Memorandum

To: Town of Southeast Planning Board
From: AKRF, Inc. (A. Ley, A. Russo, A. Auld)
Date: October 19, 2021
Re: Stateline Retail Center/Subaru
cc: Insite Engineering, Surveying & Landscape Architecture, P.C.

-Site Plan Markup (Comment 10)

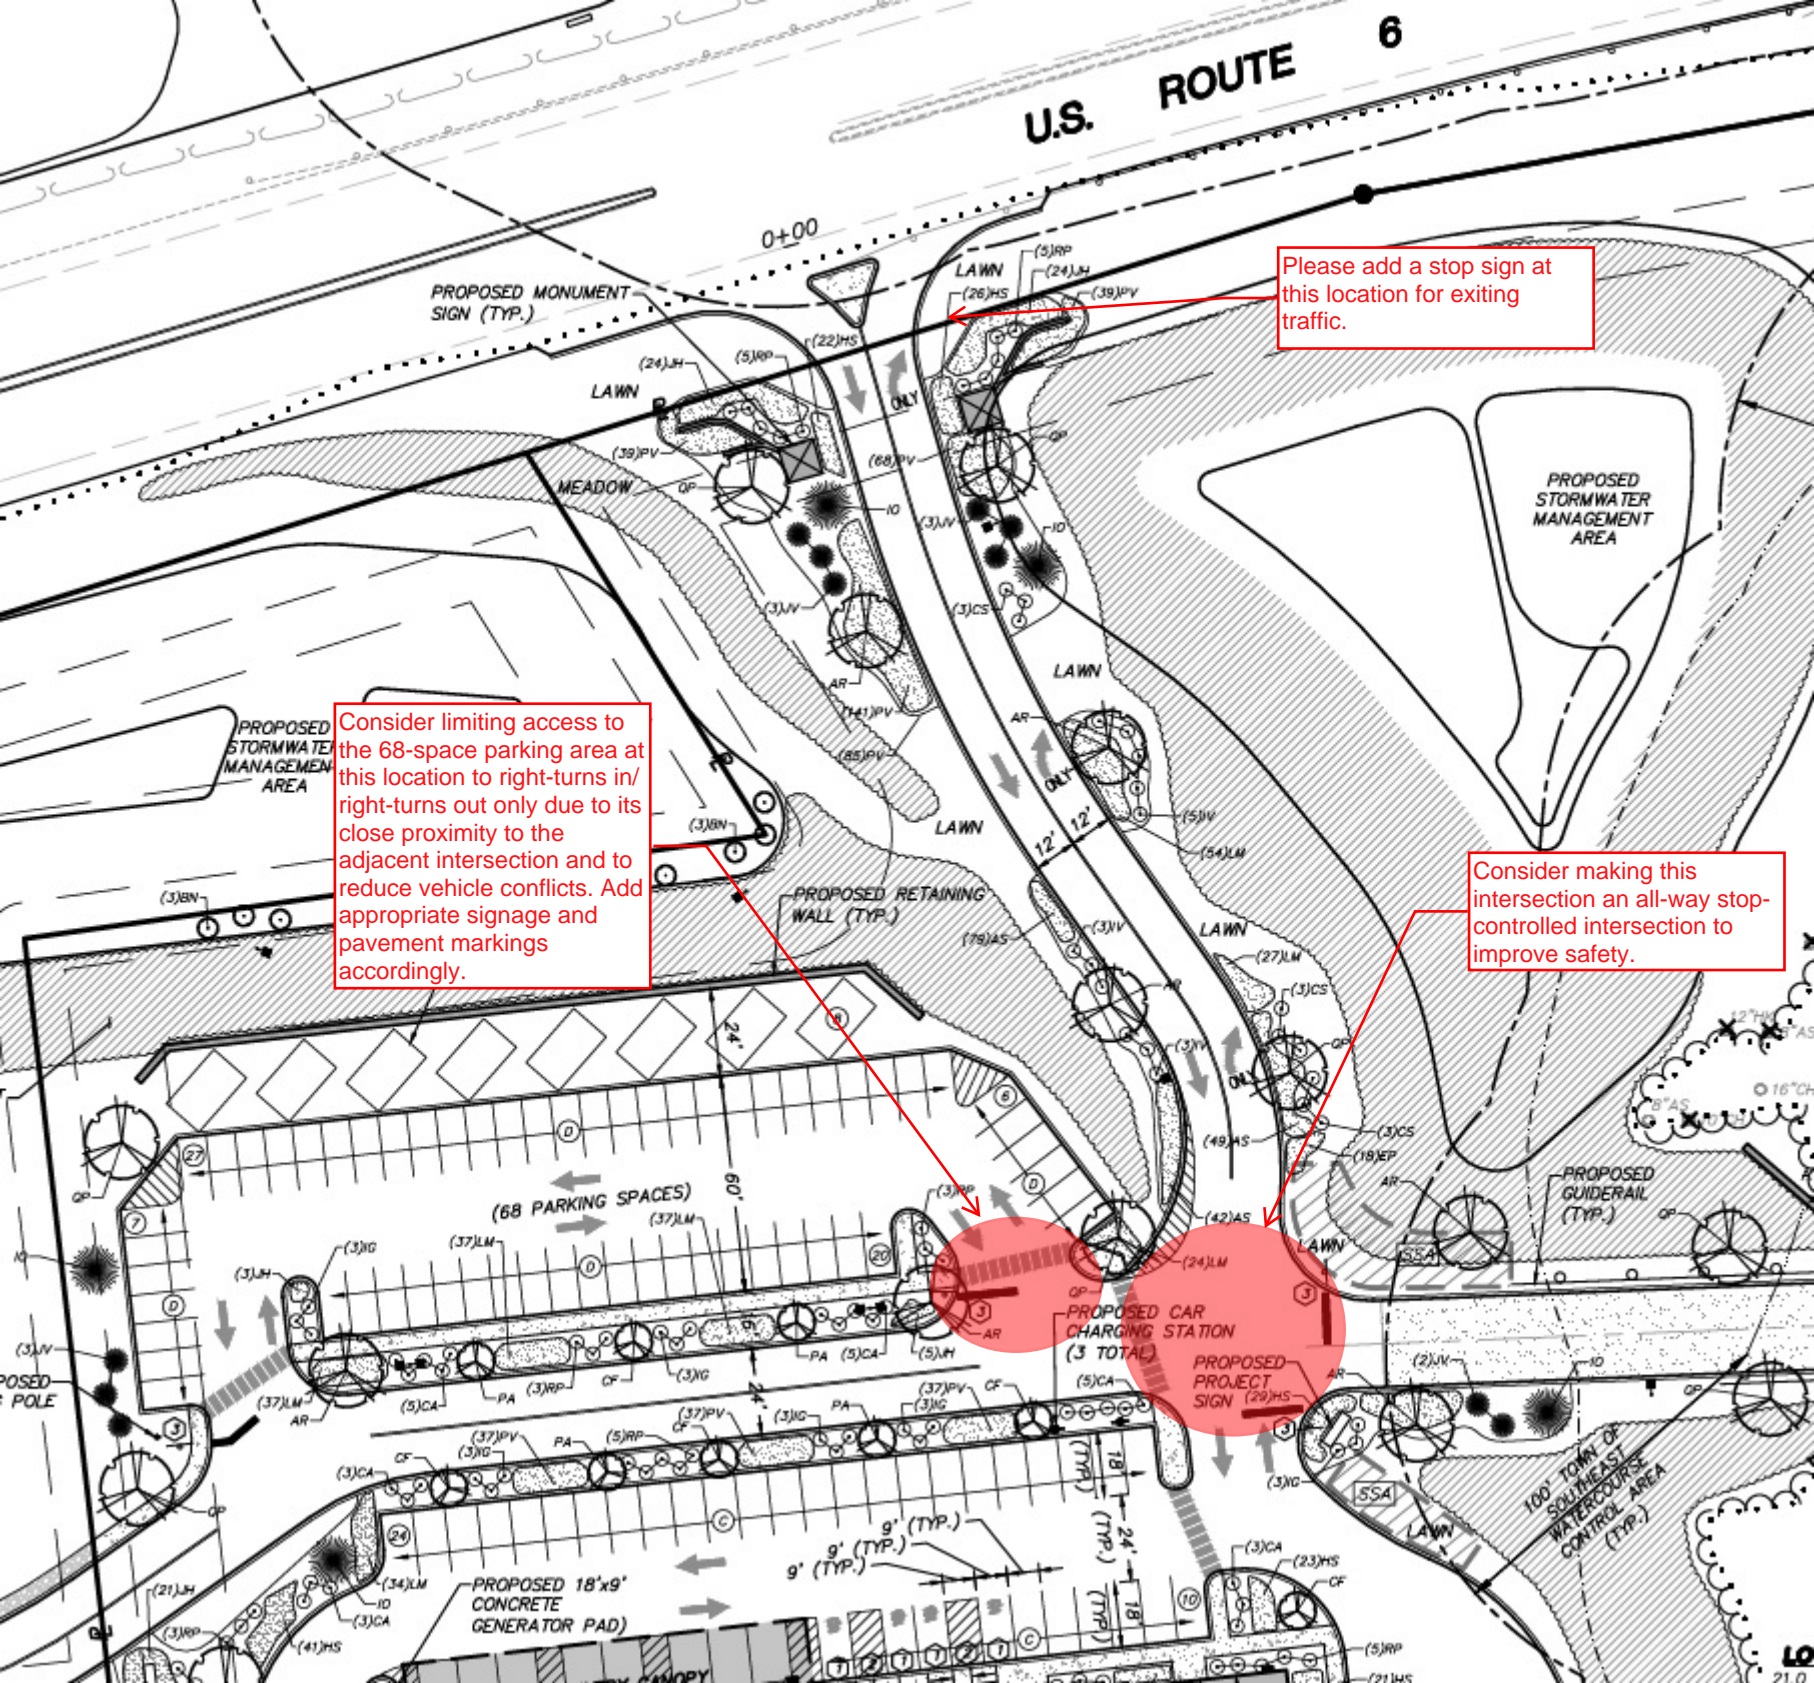
AKRF Conclusion: Comment partially addressed. Please see Attachment A for a markup of Drawing SP-1 (“Proposed Layout & Landscape Plan”) which shows the location of additional recommended signage and intersection control recommendations. Drawing VMP-1, “Vehicle Maneuvering Plan”) as provided by the Site should clearly identify and label the designated area for truck loading and unloading areas.

Please add a stop sign at this location for exiting traffic.

Consider limiting access to the 68-space parking area at this location to right-turns in/right-turns out only due to its close proximity to the adjacent intersection and to reduce vehicle conflicts. Add appropriate signage and pavement markings accordingly.

Consider making this intersection an all-way stop-controlled intersection to improve safety.
